CITY OF HOLLADAY PLANNING COMMISSION MEETING AGENDA

Date: Wednesday, February 19, 2014
Location: Holladay Municipal Center - 4580 S 2300 E
Time: 7:00 PM

Project Name: Murano Subdivision Stream Exception
Application Type: Request exception to minimum 100' building setback from Perennial Waterway
Nature of Discussion: Discussion with Possible Decision
Notice: Notice mailed February 7th 2014
Planner: Jonathan Teerlink and Clarence Kemp, City Engineer

RE: Proposed Murano at Spring Creek Subdivision
Consent of City Engineer for construction within 100 foot of Spring Creek

**Proposed Location  
Holladay Condominiums  
2350 E Murray-Holladay Rd.  
(.8 acres)**

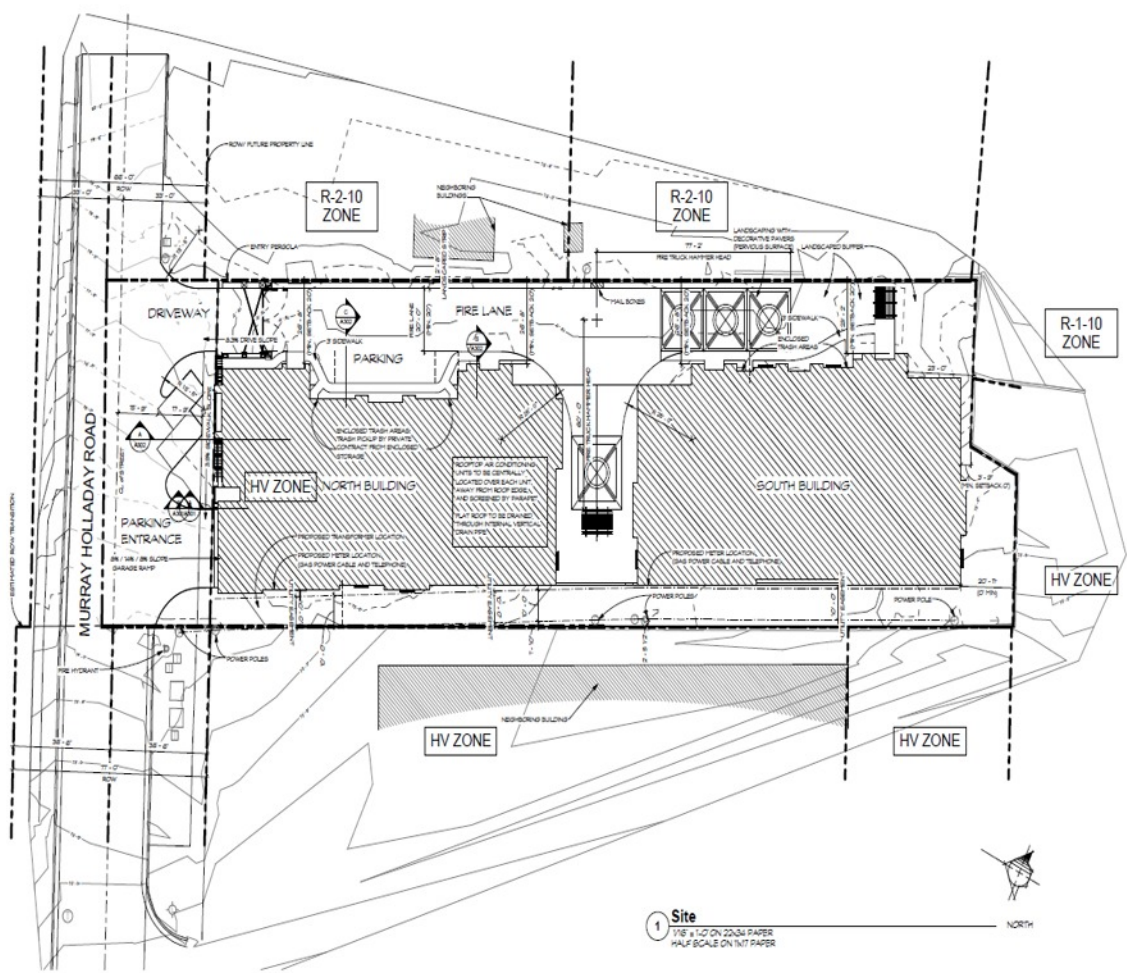
- **Site Plan.** The site plan is well developed for conceptual review. The building has been moved eastward approximately 10 feet from the boundary with The Store Too due to power lines on the shared property line. Otherwise the building would have been located with virtually no setback between the properties due to both being in the HV zone. Unfortunately for the applicant, this pinches the site in a way that has caused some concern from a neighboring property owner who believes the proposed location of the building violates setback, graduated height and landscaping requirements.

Staff has discussed setback issues at length with the applicant and one neighbor. The commission should look closely at the relationship of the southeast corner of the proposed south building where it is very close to the intersection of the property lines for three properties; two in the HV zone and one in a single family zone. **Please refer to the site plan.**

It is at this point where there is conflict and where the commission will need to determine a proper outcome. The essential problem is one of appropriate interpretation of setback. The developer shows compliance with setback as measured in the way that makes sense from his point of view and in his interpretation of the ordinance. Likewise, the neighbor effectively argues that the building is far too close to the property line as she interprets the ordinance. Staff suggests that the setback as shown on the plan is perhaps technically correct in that the building does not parallel the neighbors' property where a standard perpendicular measurement of distance from building to property line is usually performed. Using that standard, the building complies with the 20-foot setback requirement for both neighboring residential properties. Conversely, the neighbor effectively argues that the HV zone 20 foot buffer setback to neighboring residential property is violated by the southeast corner of the building which is perhaps as close as 3-6 feet to her property line using a diagonal, straight line measurement of nearest point from structure to property line.

It is easy to see that both interpretations make sense. Staff suggests that averaging the setback, a technique routinely used in calculating setbacks in the permitting process, could be a rational way to determine setback at this location or to at least clarify thinking about intent versus application of the setback standard here. Undoubtedly, the applicant, staff and the neighbor involve the commission in a discussion about these elements during the meeting.

1. Building setback at southeast corner of south building next to single family residential
2. Graduated height at the same location.
3. Landscaping buffering
4. Maximum height of tallest vertical elements.
5. Any remaining design items required by DRB.
